Historic Preservation Commission

- I. Call to Order
- II. Adoption of Agenda
- III. Public Comment
- IV. Case A24-0224 174 South Depot Street - Certificate of Appropriateness

Certificate of Appropriateness for Major Work

Re: Response to Michael James email request for additional information dated April 23, 2024
COA Application Review (#A24-0224)
174 South Depot Street

FRONT ELEVATION

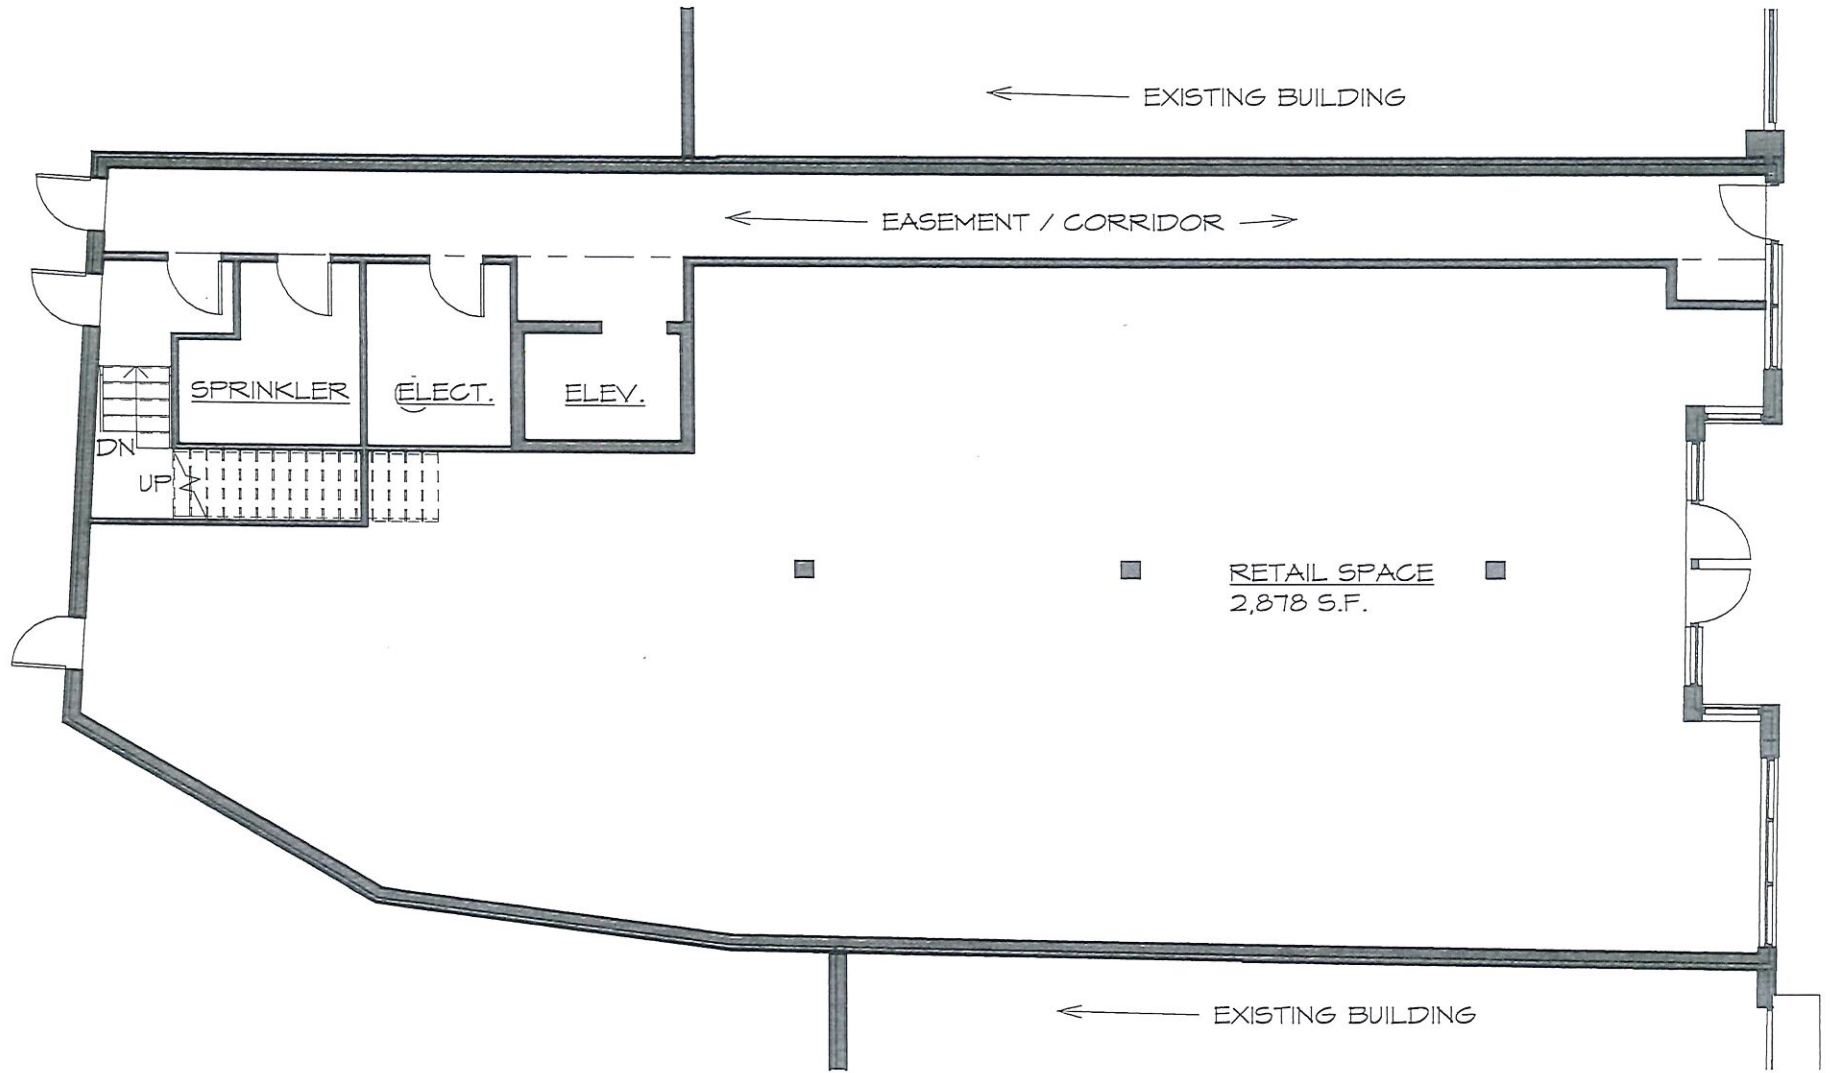
Fenestrations – Refer to the proposed 'Front Elevation' drawing dated 4/17/24

- a. The rhythm, placement, size and proportion of the proposed window and door openings are consistent with other commercial (or mixed-use) buildings in the downtown core district.

- b. Storefront windows on Ground Floor
Items: I – V: The proposed front elevation meets all of the requirements in this sub-section.
- c. The window to wall ratios meet the percentages required in the B1 Downtown Core District as noted on the Front Elevation drawing.

- d. As noted. Window glass will be clear or lightly tinted. No dark tinted or spandrel glass windows are proposed.
- e. Exterior Doors – Exterior storefront doors from the Depot Street sidewalk into the Ground Floor commercial space(s) are required by NC Building Code to open out because of potential occupancy load in the commercial area. As such, the doors will be recessed so that they will swing out on the subject property and not encroach onto the town owned sidewalk.

The exterior door on the right side of the front elevation is to access the hallway to the stair and elevator to the 2nd floor level apartments. Because of the limited occupancy numbers in the 2nd level apartments, this door can open into the hallway and will not be recessed.

BUILDING SECTION

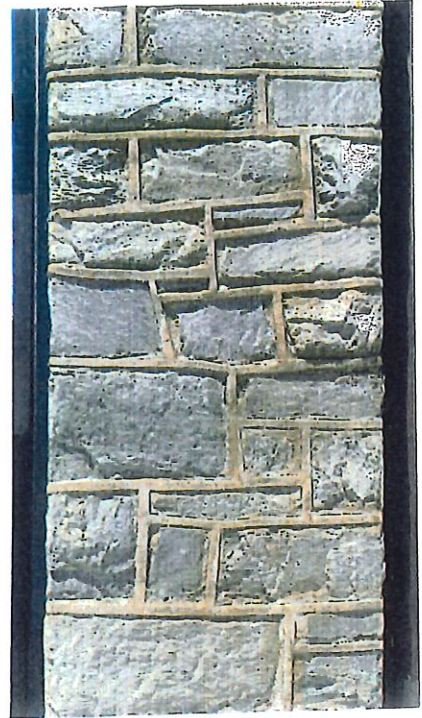
6. Single slope roof- See attached building section showing the proposed (minimal) roof slope; sloping from the front parapet wall down to the back of the building where water will be collected in a gutter and released in an approved storm water system. Mechanical units will be located on the roof and screened from view.

Proposed stone- "Chocolate Gray, Snapped & Elongated stone" from a Mt Airy quarry.

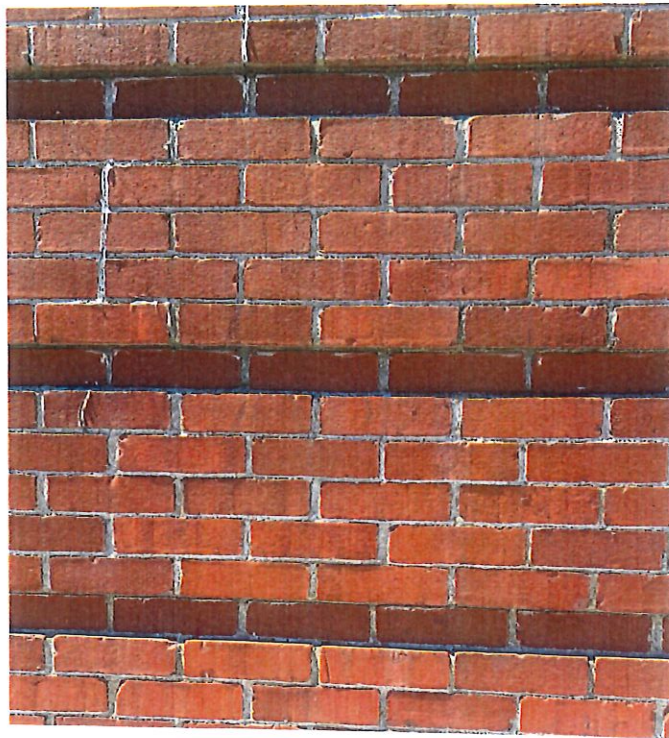
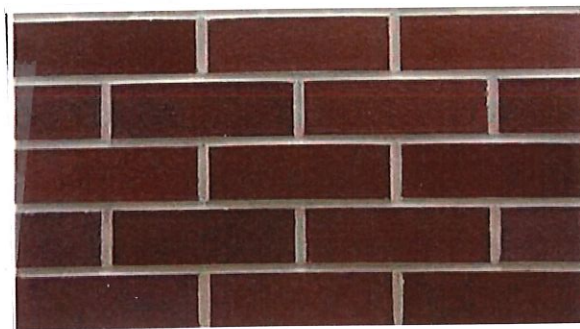
3. Stonework The proposed stonework closely resembles the 1940's stone on the Greenhouse building next door to the subject property. According to Woods Masonry, this is a "Chocolate Gray, Snapped & Elongated stone" from a quarry in Mt Airy. It is the Applicant's opinion that the stone on the building of the Speak-Easy Tattoo business on King Street is more reflective of the colors of the southwestern USA and not reflective of the gray colors seen in stone native to the NC mountains. Please also refer to the attached photographs. A rectilinear grey colored concrete "medallion" is proposed at the top of the South Depot Street façade which resemble the concrete medallions on the original 1939 Brendle's garage building.

4. Brick The proposed brick is to be a Endicott-Medium Ironspot #46 modular brick laid in a standard running bond pattern w/ grey mortar. Refer to photograph. The pattern of the brick will be similar to the horizontal pattern on the original 1939 Brendle's Garage building with a ¾" brick reveal at every 6-8 brick courses vertically. This treatment is proposed on all visible portions of the front, North and South sides, and rear of the building.
